GATEWAY PORTABLES & SHADE STRUCTURES

Bid Clarification 01

September 21, 2026

DSA Application Number: 01-122796

SHEET NUMBER
C-3.2

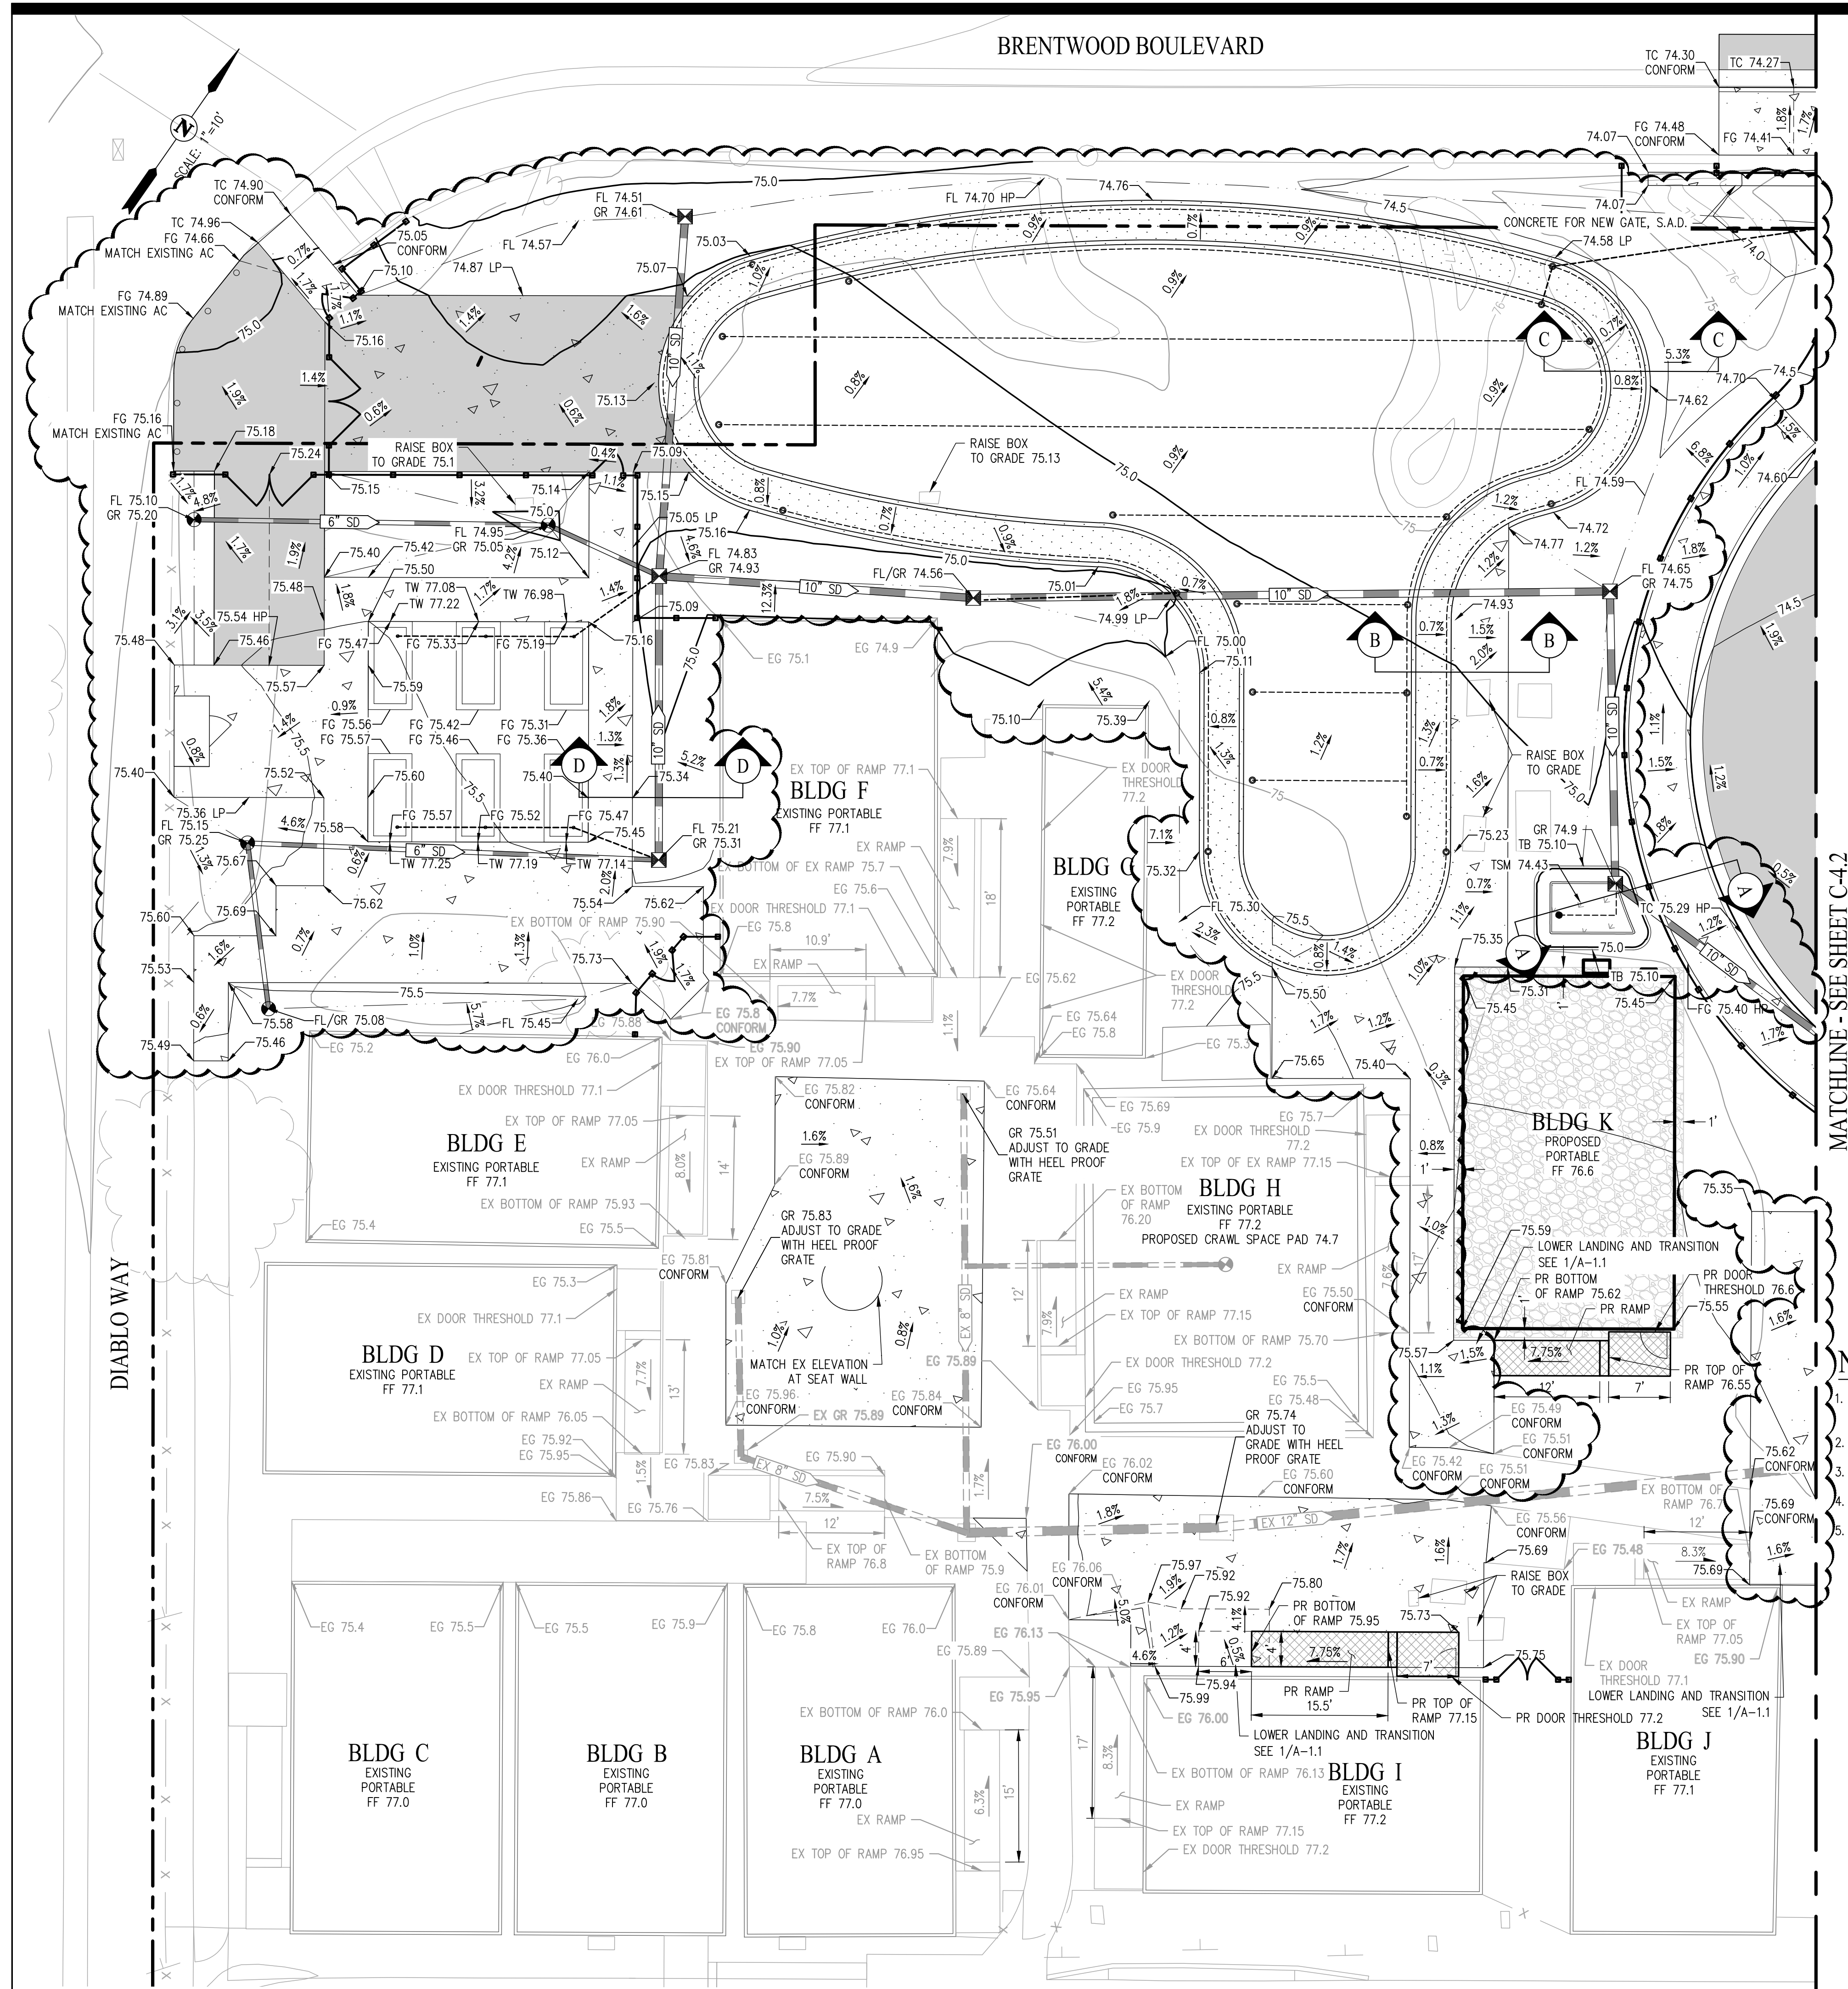
C-3.2 Utility Plan

- Utility Plan revised in its entirety reflecting the new site improvements.

SHEET NUMBER
C-4.1

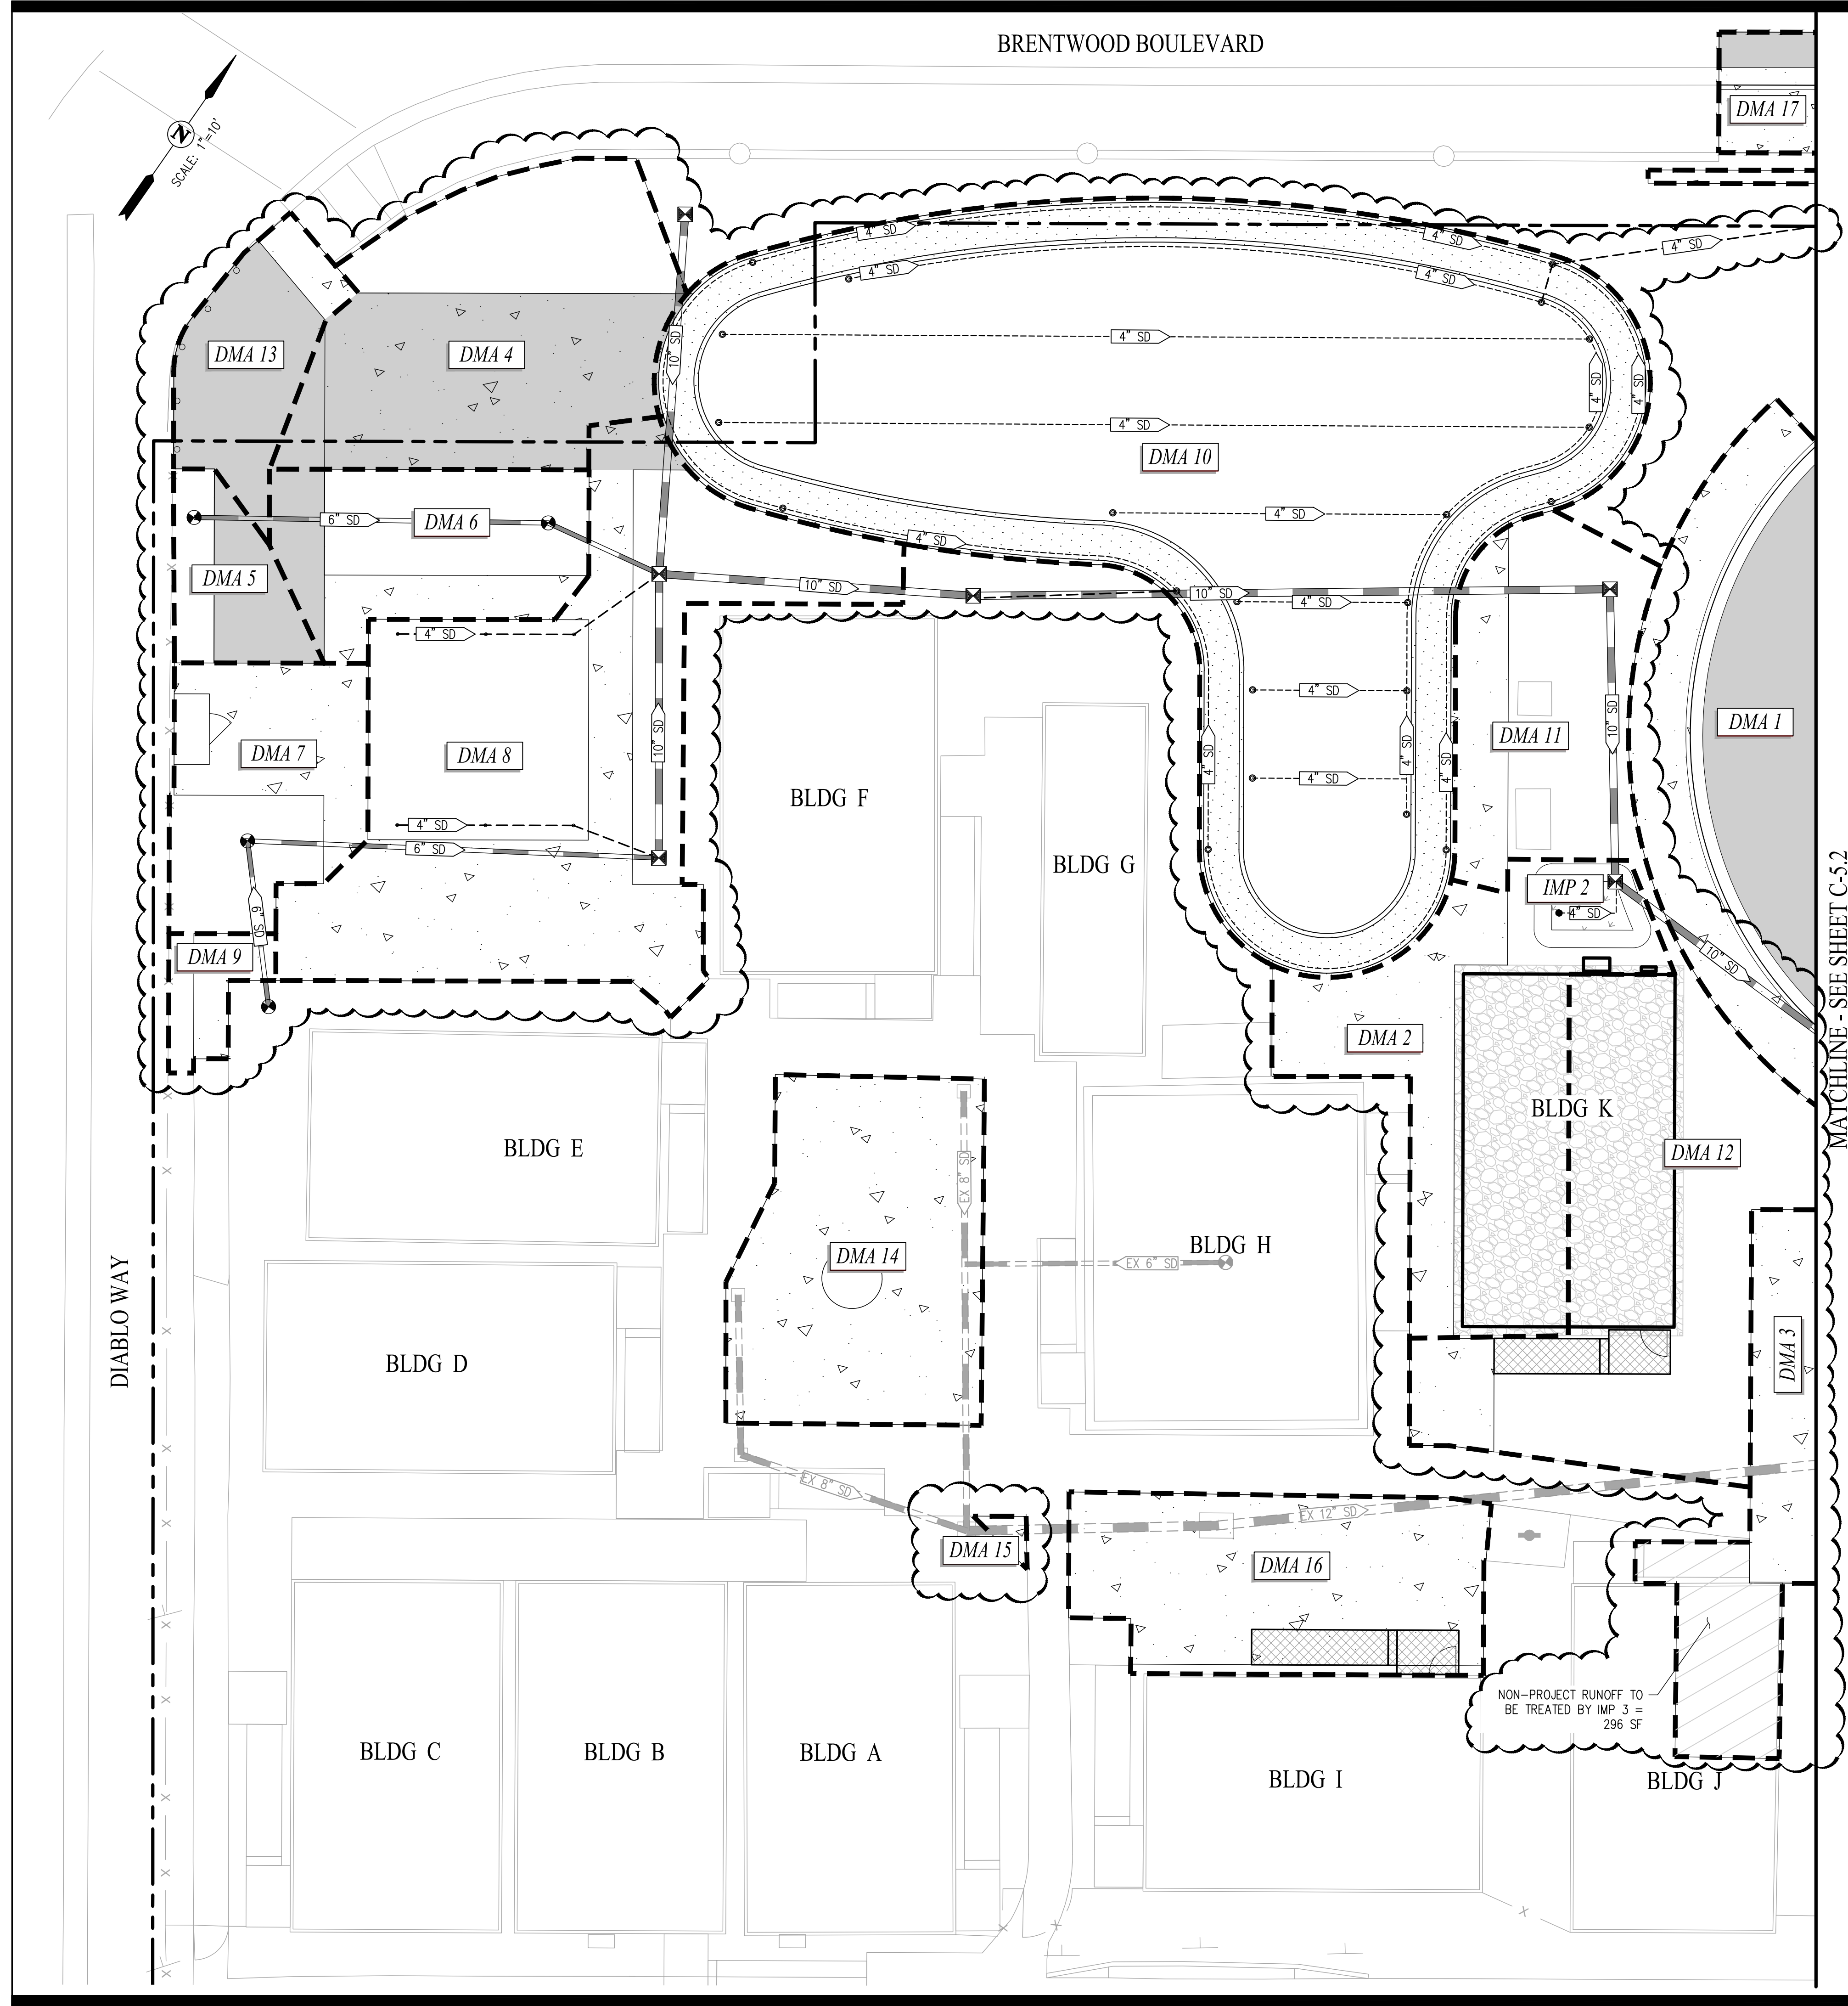
C-4.1 Grading Plan

- Grading Plan revised in its entirety reflecting the new site improvements.
- Grading sections in the area of new site improvements added.

SHEET NUMBER
C-5.1

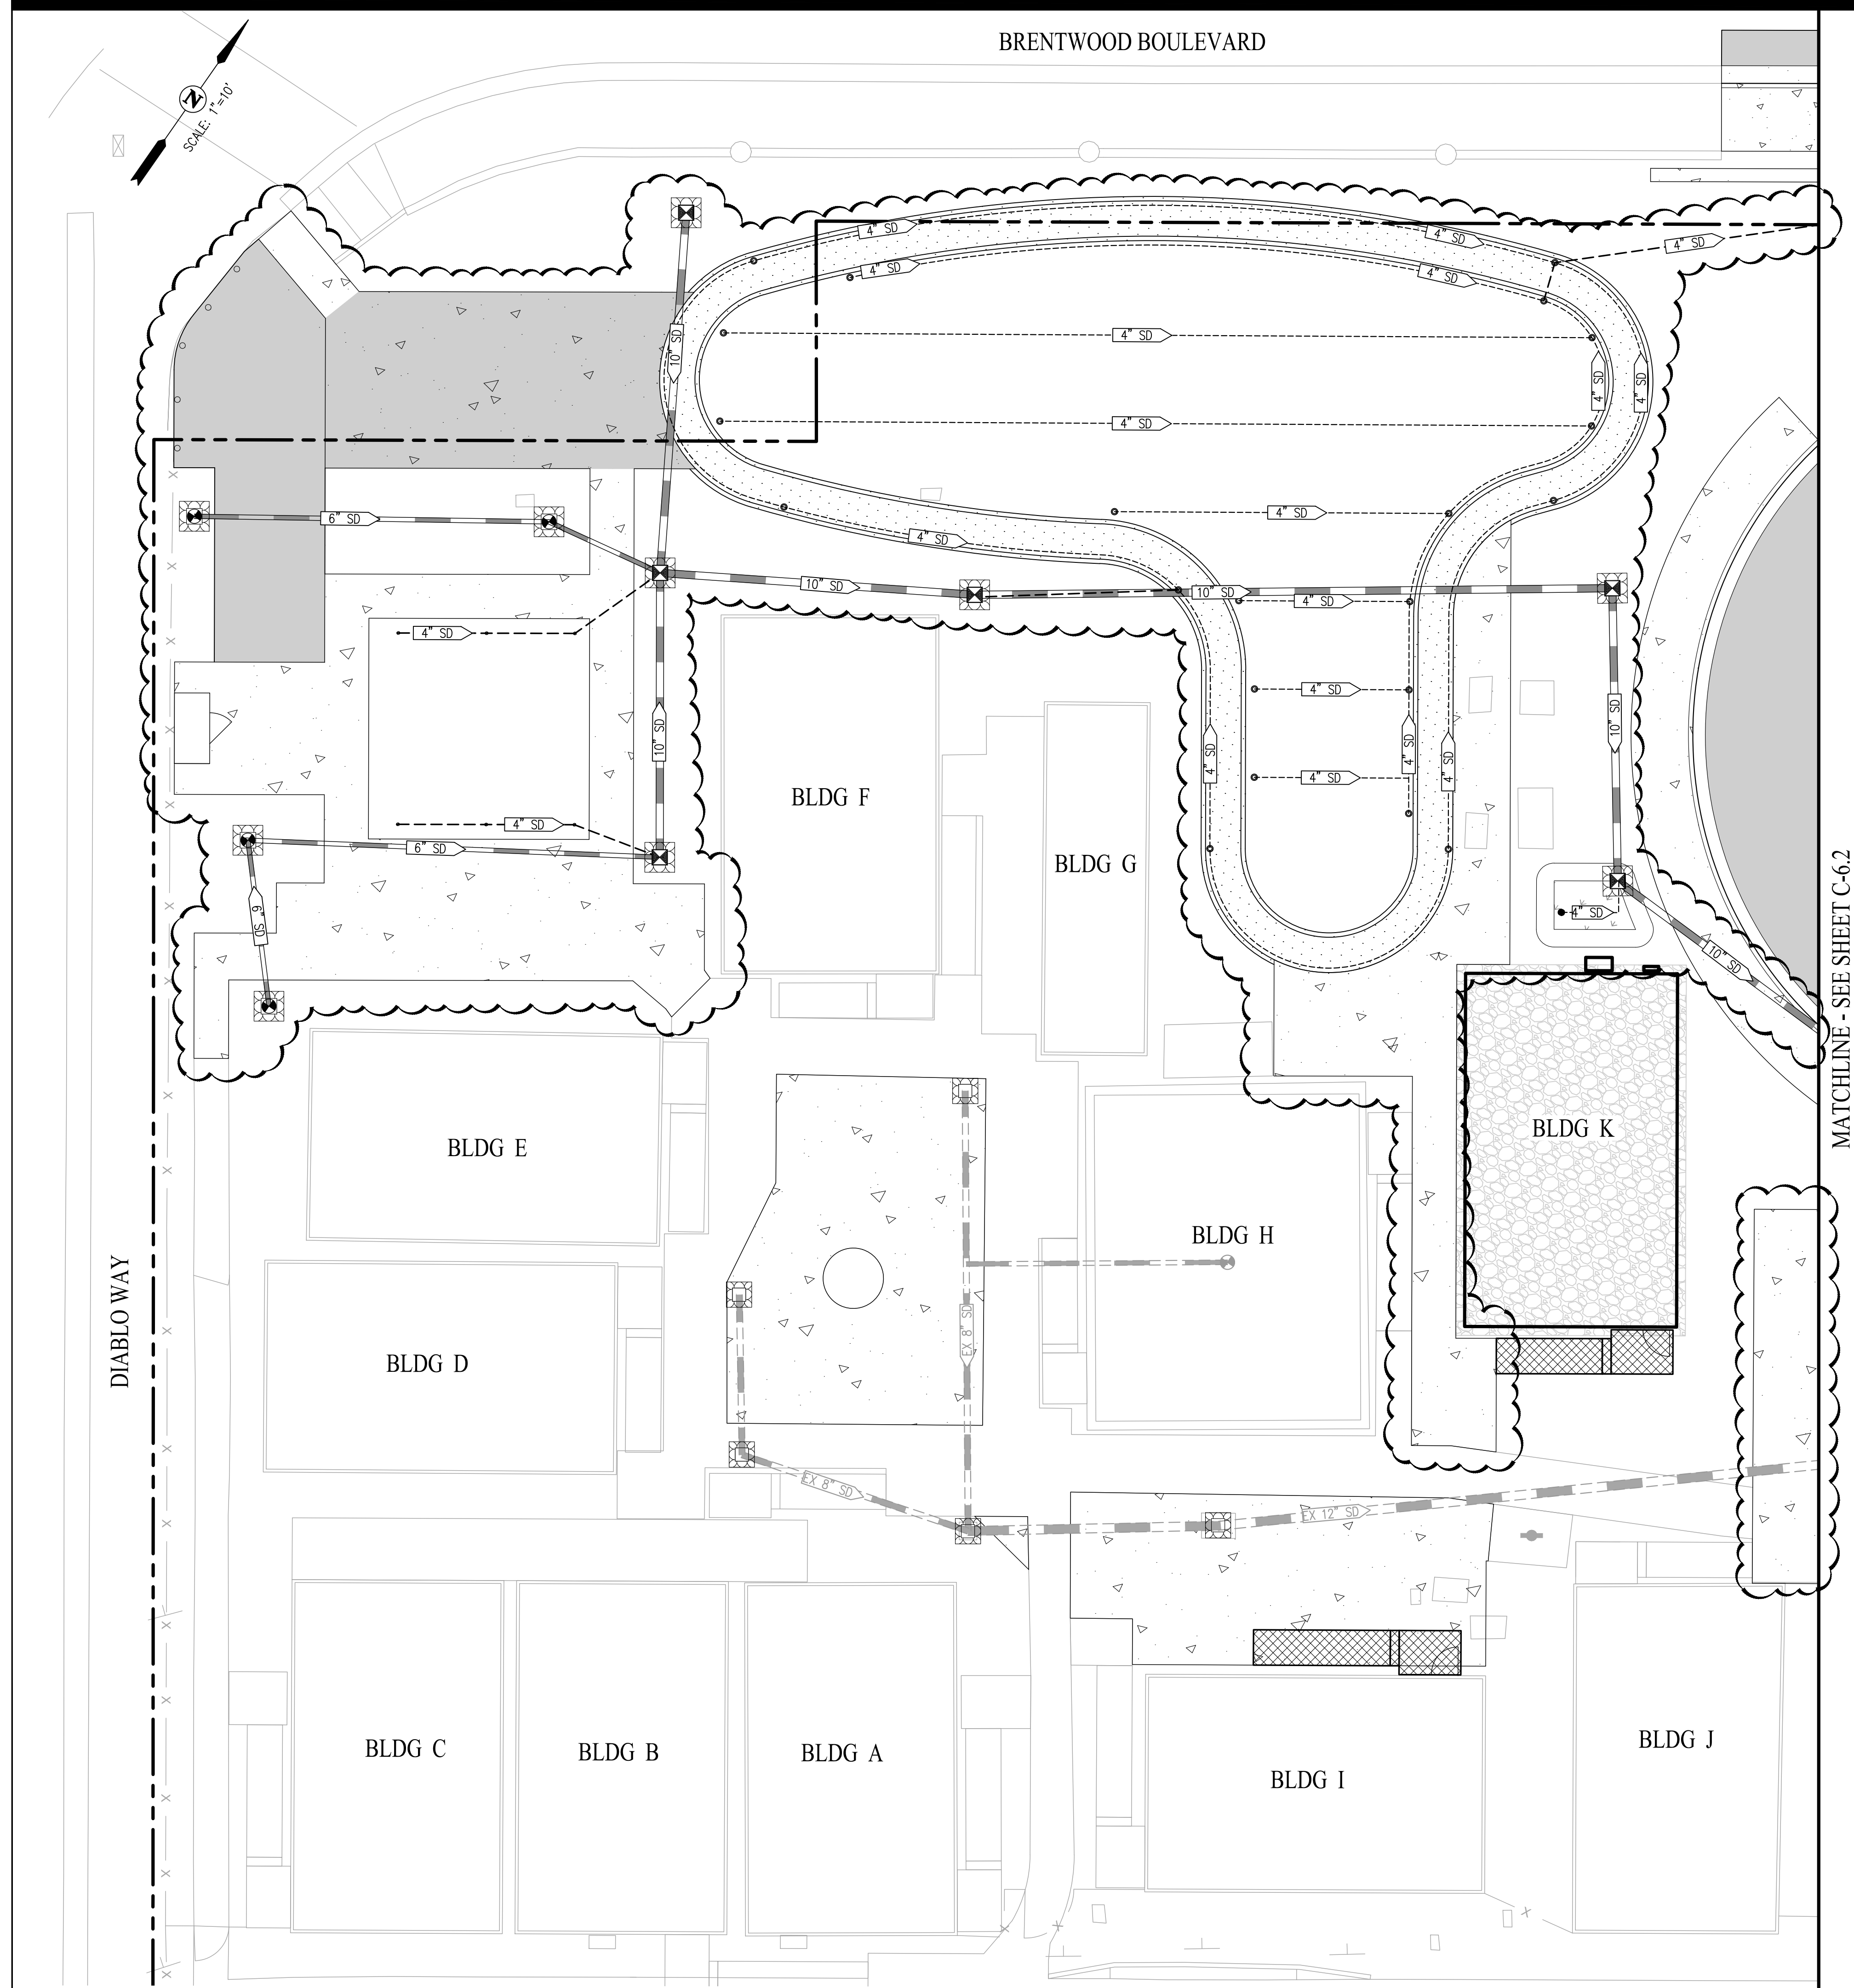
C-5.1 Stormwater Control Plan

- Stormwater Control Plan revised in its entirety reflecting the new site improvements.
- Bioretention areas table updated.
- Bioretention area section added.
